06V-352  
(8 Pages)

Re: Workhorse Custom Chassis, Recall Bulletin No. 60601-C; 8.1 L Engine Fuel Rail Damper Retainer Clip

**BULLETIN NO:** 60601-C

**SUBJECT:** 8.1 L Engine Fuel Rail Damper Retainer Clip

**Photo 2 and 3 retaining clip and damper held by the clip**

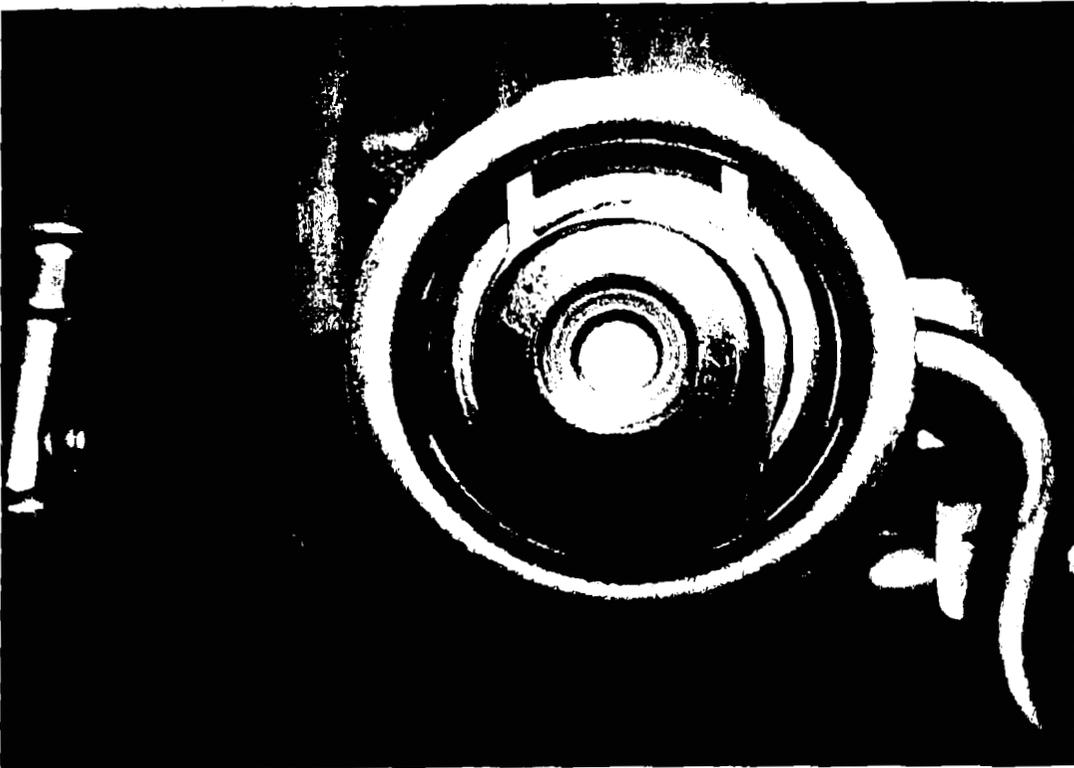
**The defect involves the possible installation of an improperly heat treated fuel rail damper retainer clip. An improperly heat treated clip may break resulting in a gasoline fuel leak at the fuel rail damper. A vehicle fire can result if the leaking fuel is ignited by a spark, or flame.**

6. Push down on the fuel damper while using a flat screw driver to remove the existing clip. (See photos 2 and 3)
7. Do not remove the fuel damper from the fuel rail. If the damper is removed the fuel damper o-ring must be replaced at the technician's/dealer's expense.

8. While holding down the damper, install the new clip in same position as removed clip.
9. Reconnect the negative battery cable.
10. Tighten the fuel filler cap.
